Change Notice

JWS Series

Change to Logo & Cap Material for JWS Rockers

Change to JWS Cap Material Results in UL Approval Difference

JWS Rocker

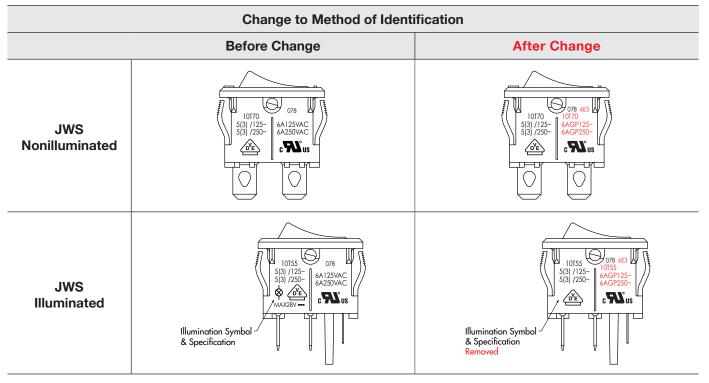
- 🗹 Engineering 🛛 Part Number
- Product
- ☑ Appearance
- 2. Due to the change in rocker cap material, the UL standard number will change from UL 1054 to UL 61058-1, and the approval marking will be revised on the switch case.

These changes will effect both standard and custom products of the JWS Series. The illustrations below depict standard nonilluminated and illuminated switches before and after the revisions.
